REQUEST FOR AMENDMENT
TECHNICAL SPECIFICATION SR 3.5.2.2
CONDENSATE STORAGE TANK WATER LEVEL
Attachment 3

Marked-Up Version of Technical Specification 3.5.2.2 and Associated Bases

**REQUEST FOR AMENDMENT
TECHNICAL SPECIFICATION SR 3.5.2.2
CONDENSATE STORAGE TANK WATER LEVEL
Attachment 4**

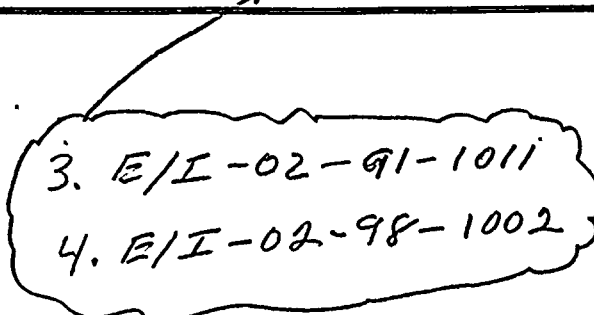
When the suppression pool level is < 18 ft 6 inches, the HPCS System is considered OPERABLE only if it can take suction from the CST and the CST water level is sufficient to provide the required NPSH for the HPCS pump. Therefore, a verification that either the suppression pool water level is ≥ 18 ft 6 inches or the HPCS System is aligned to take suction from the CST and the CST contains $\geq 135,000$ gallons of water, equivalent to a level of 13.25 ft in a single CST or 7.6 ft in each CST, ensures that the HPCS System can supply makeup water to the RPV. above the top of the suction line. This

This volume of water is

9.1

14.8

Calculations that determine this water level are listed as References 3 and 4.
